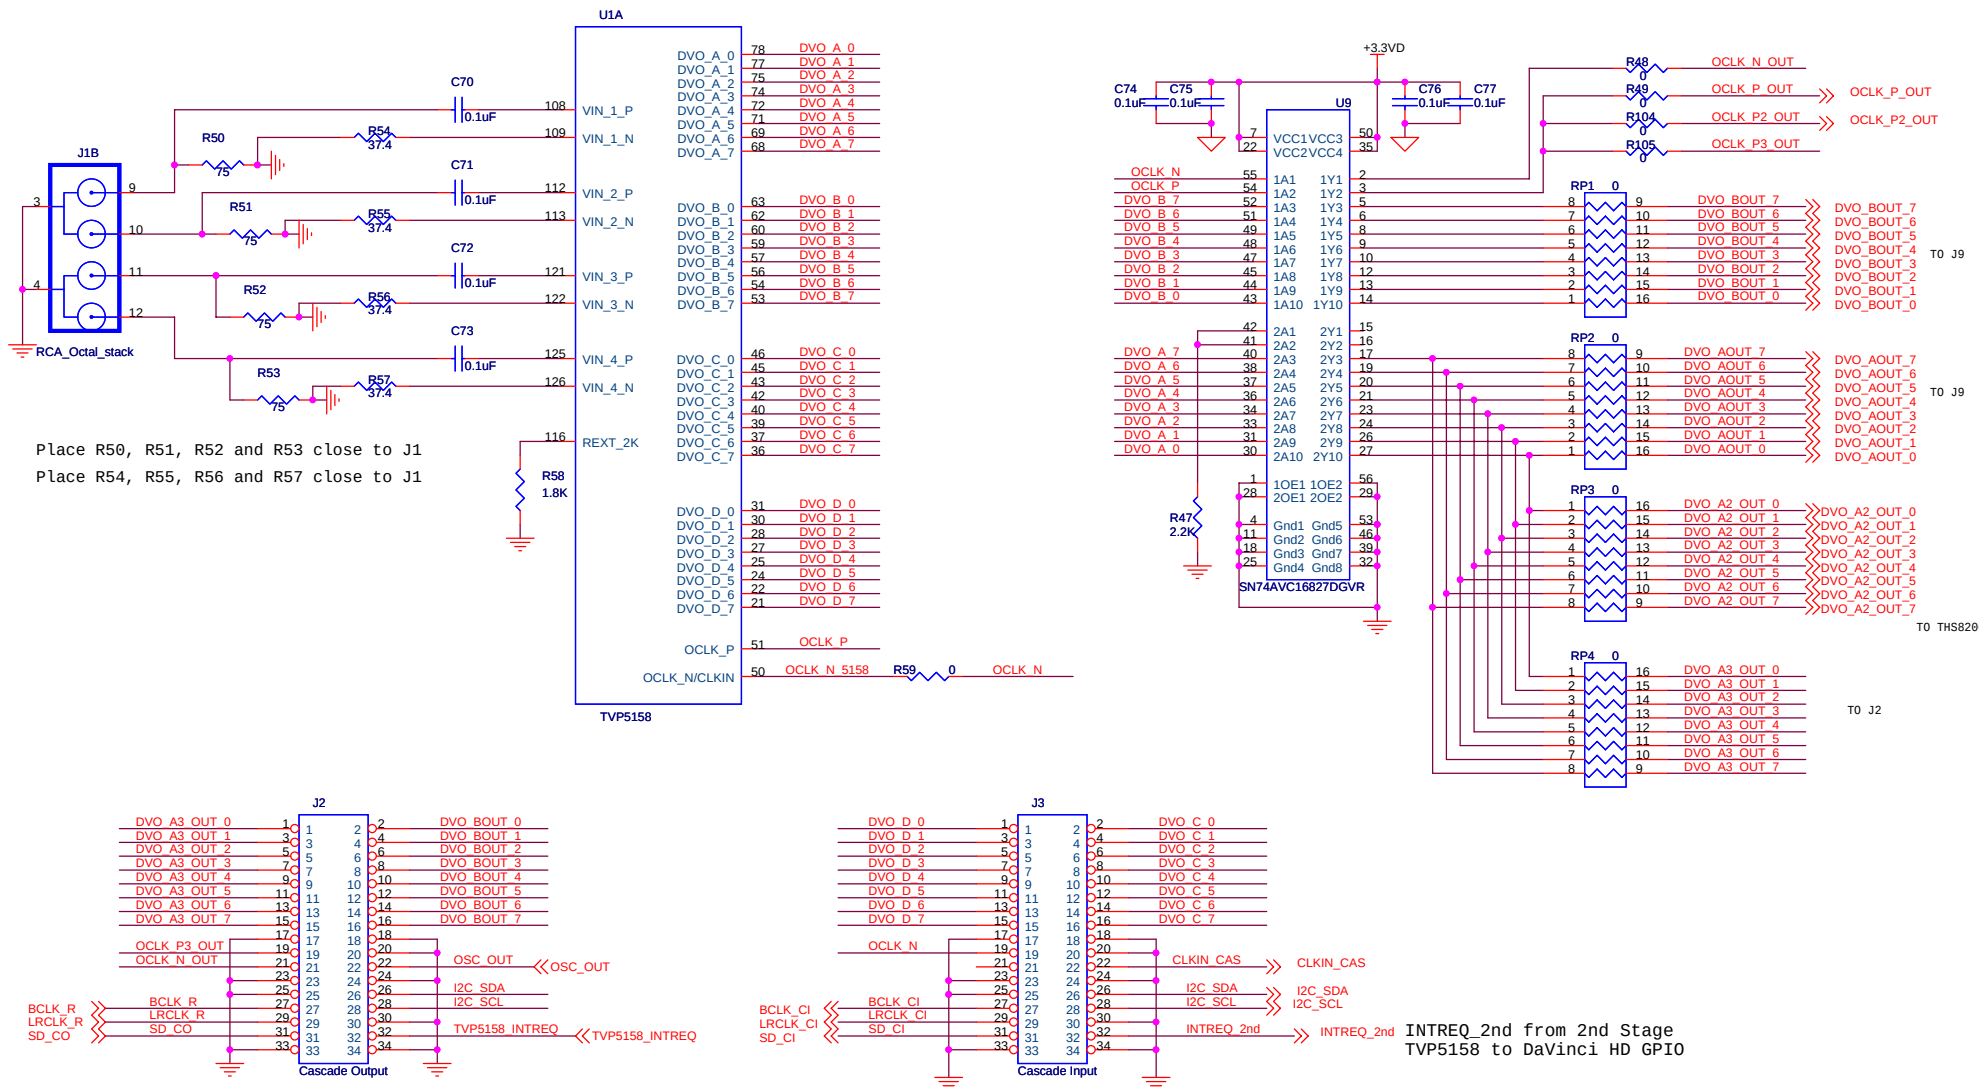
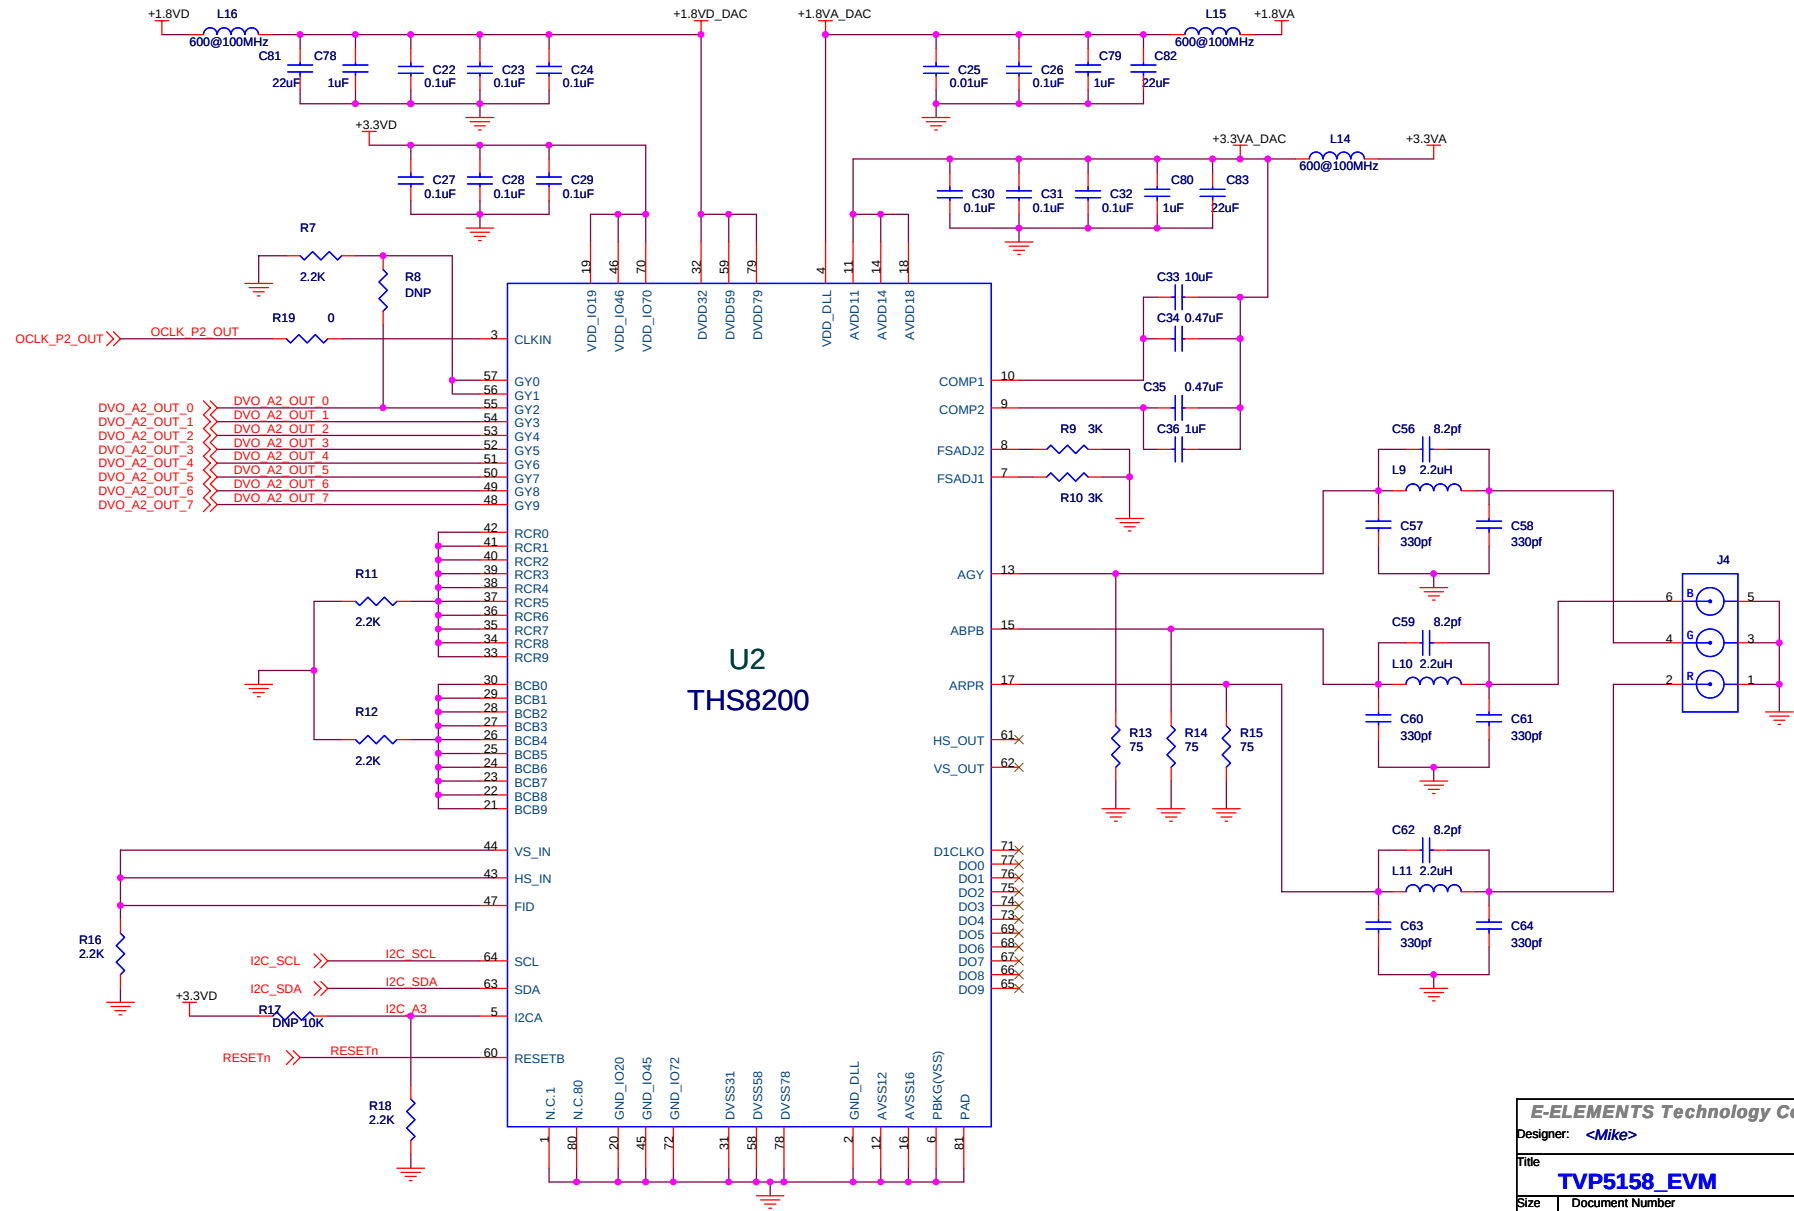
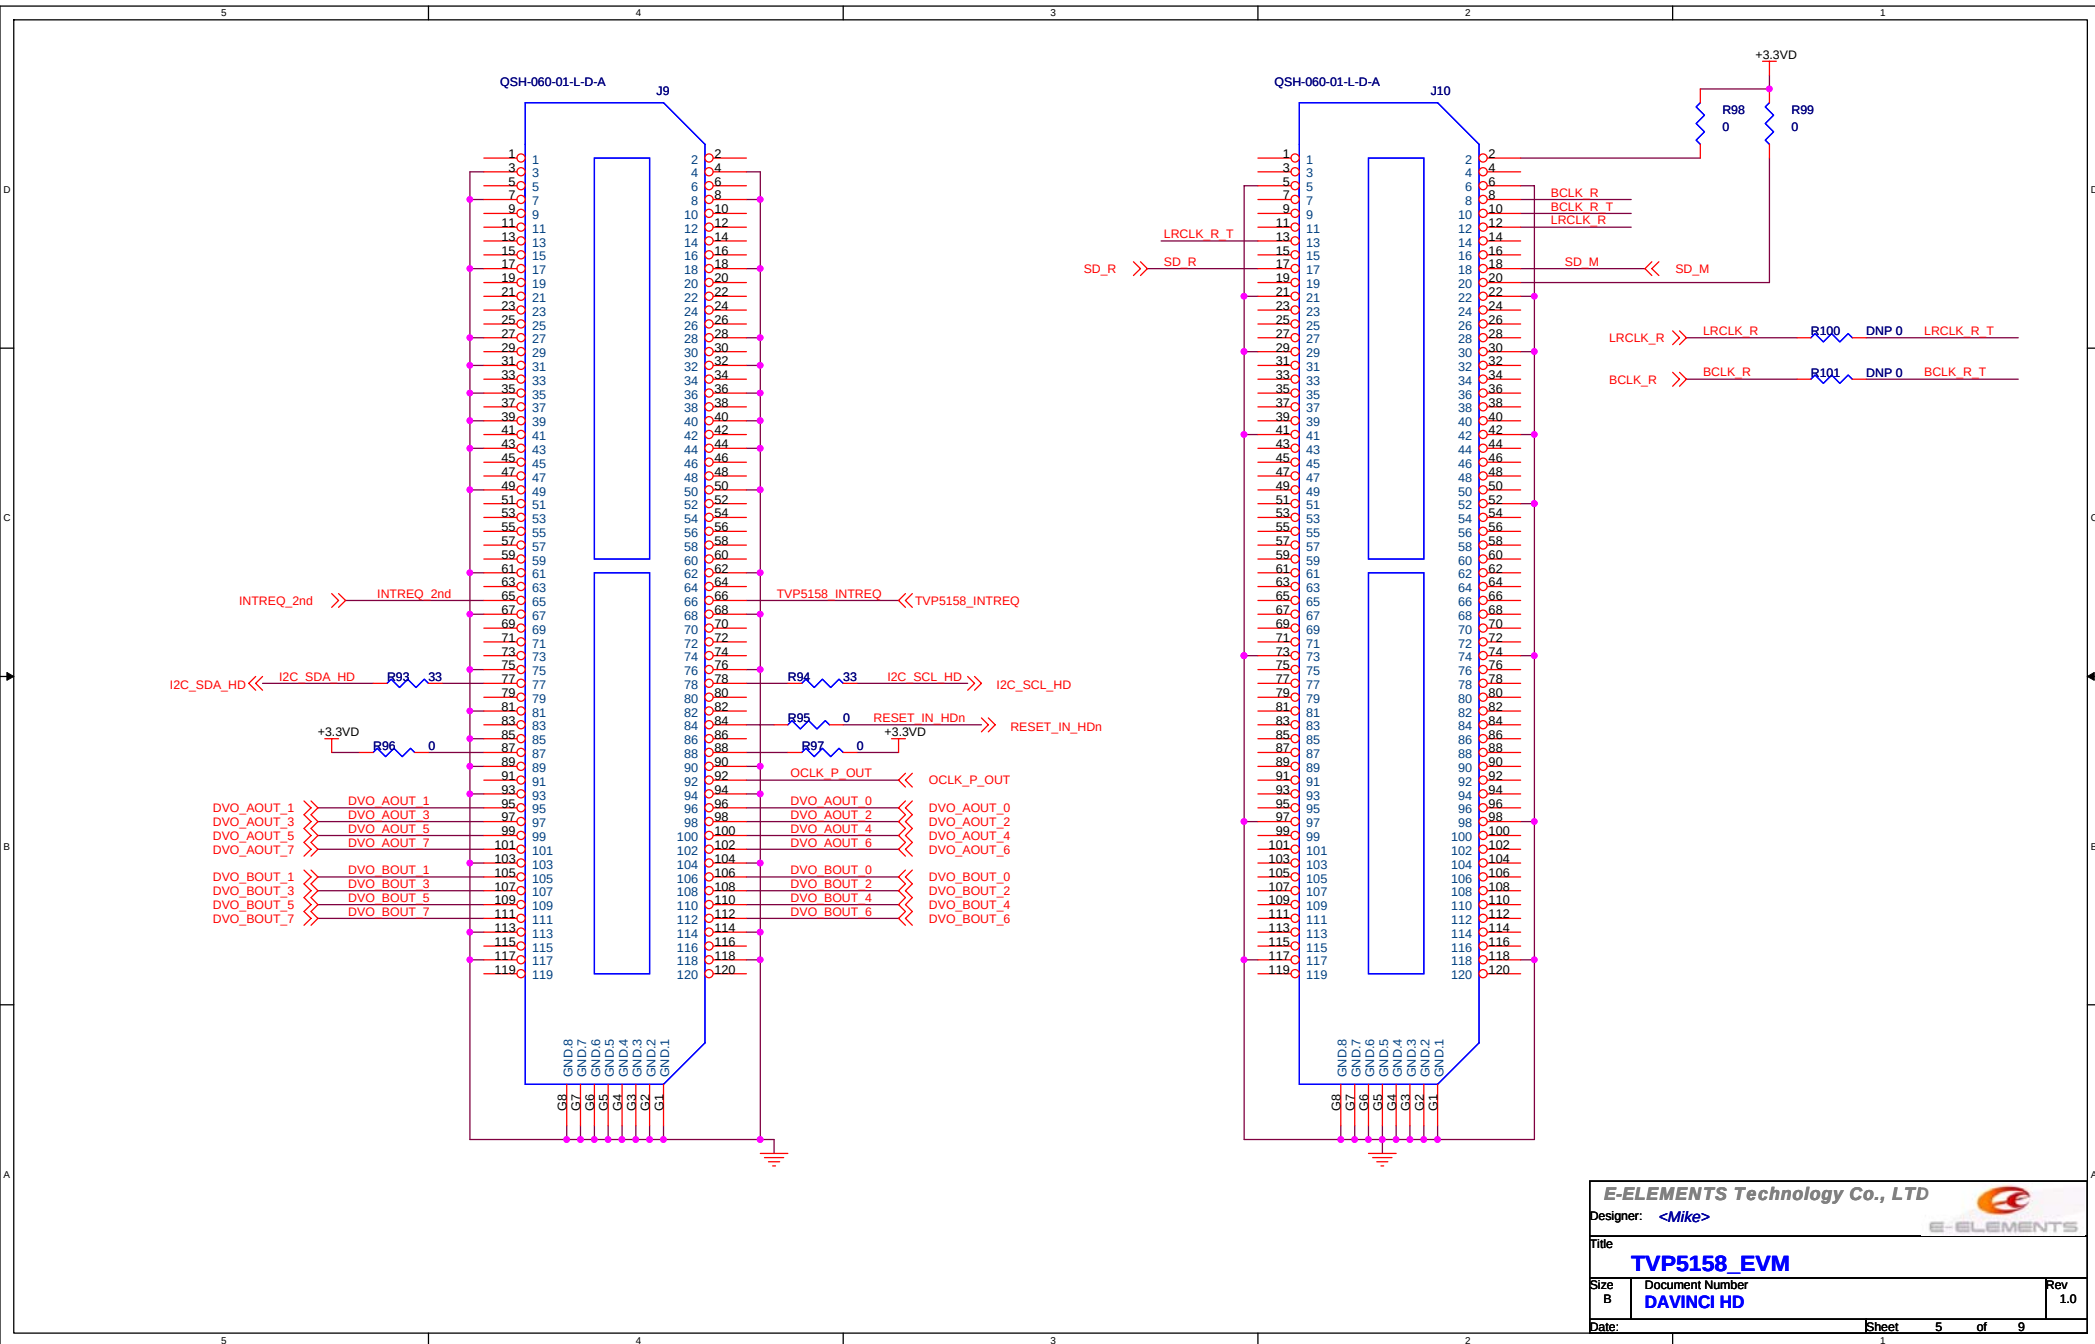
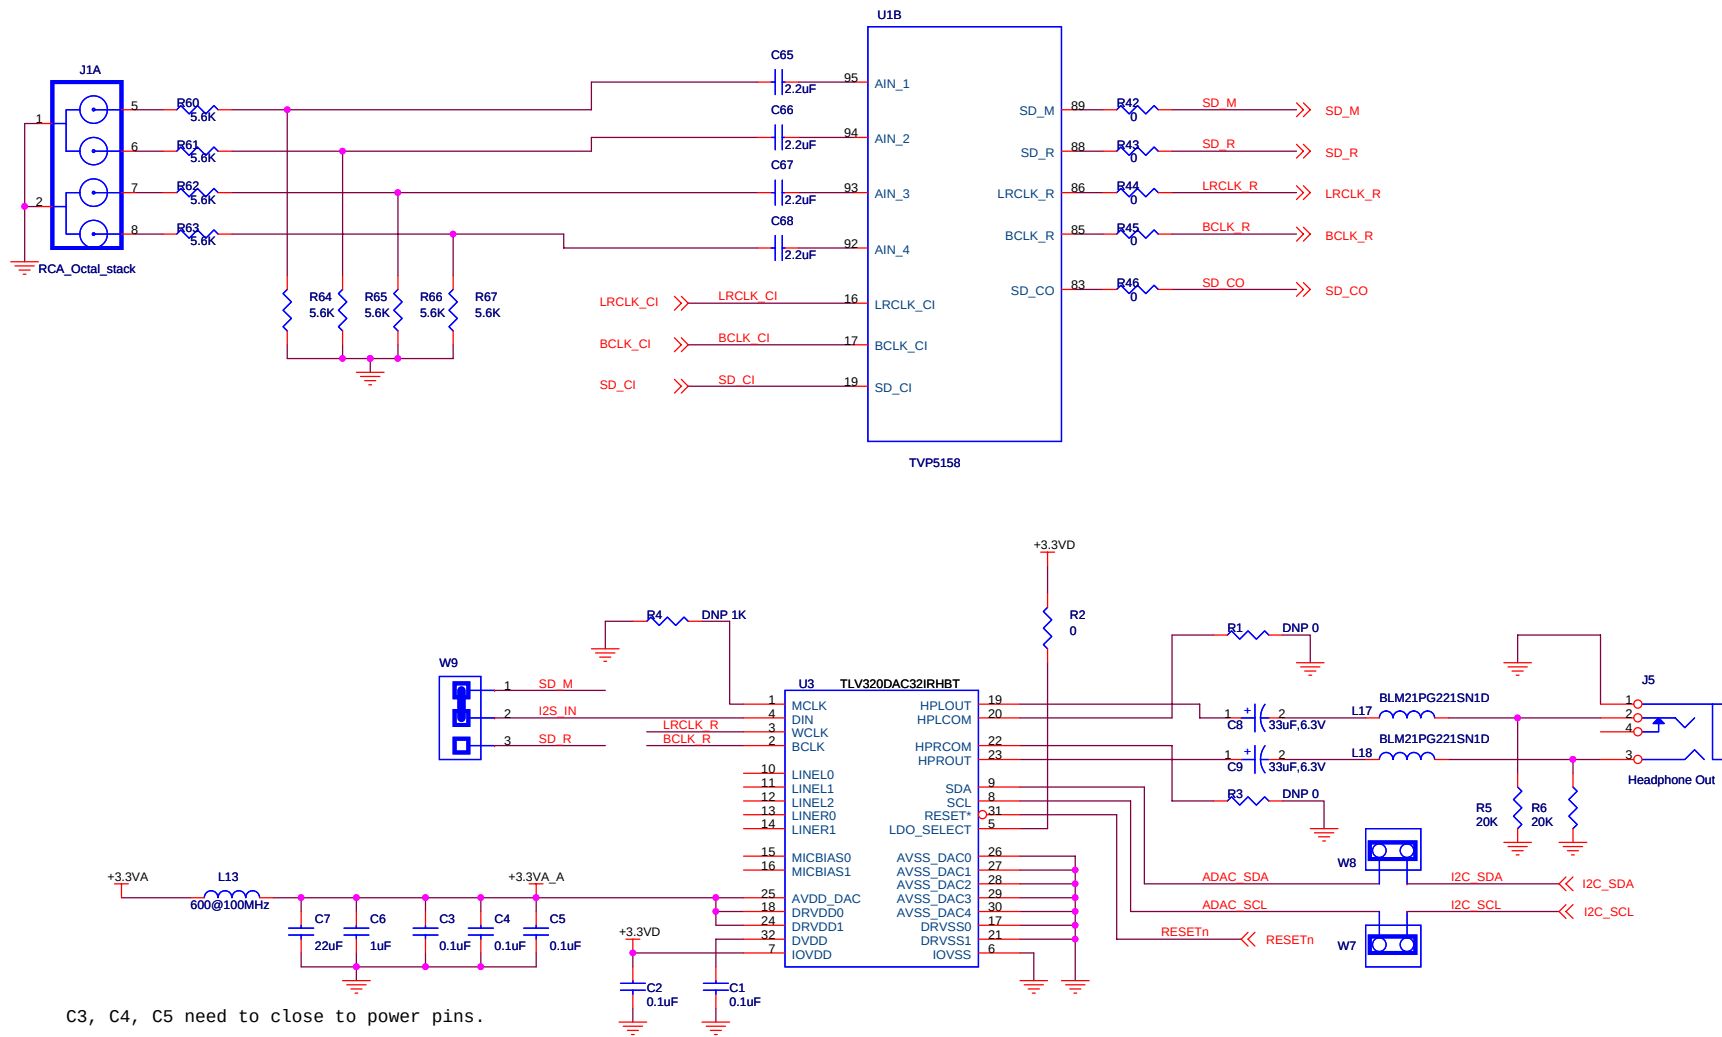
C3, C4, C5 need to close to power pins.

+3.3V_A is local analog power supply only for Audio DAC
